**SAFETY AUDIT OF HIGHWAY SCHEMES – REQUEST FORM**

Scheme name :- A386 VALE DOWN ROAD MARKINGS.

## STAGE 3b SAFETY AUDIT

#### **A386 - Vale Down Road Markings**

SITE PLAN (A)

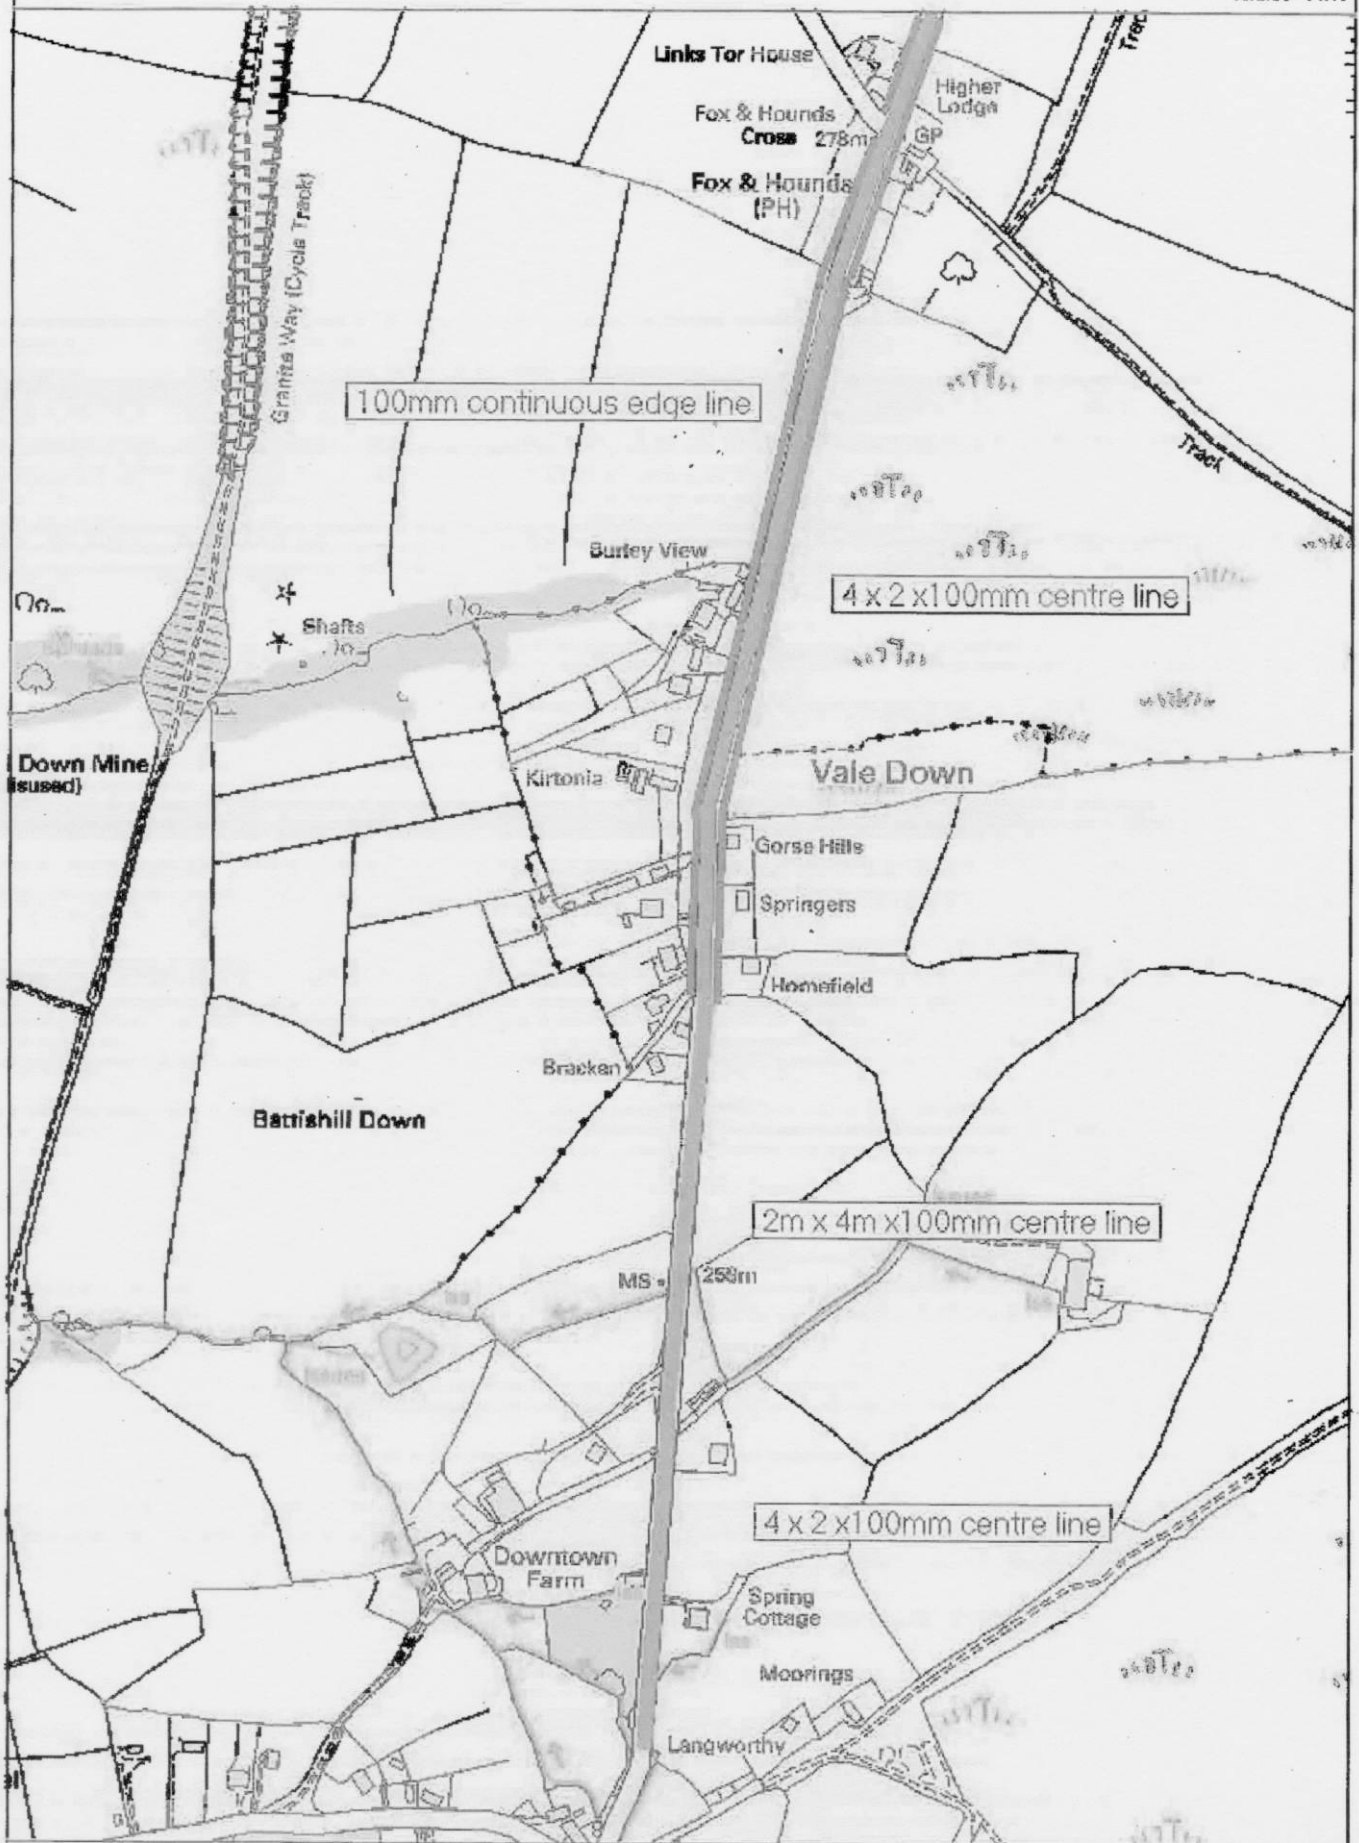
B1	PROBLEM	<p>The lining scheme appears to end at the extent of the surfacing scheme.</p> <p>The result is that hazard centre lining terminates at a double white line system at the southern end of the scheme with no formal transition.</p> <p>There are no deflection arrows at the end of the hazard line system forming the transition.</p> <p>It is possible this could render the double white lines unenforceable.</p>
	RECOMMENDATION	<p>a) Create an appropriate transition,</p> <p>or</p> <p>b) Survey the need for the double white line system and if redundant, apply appropriate lining.</p>
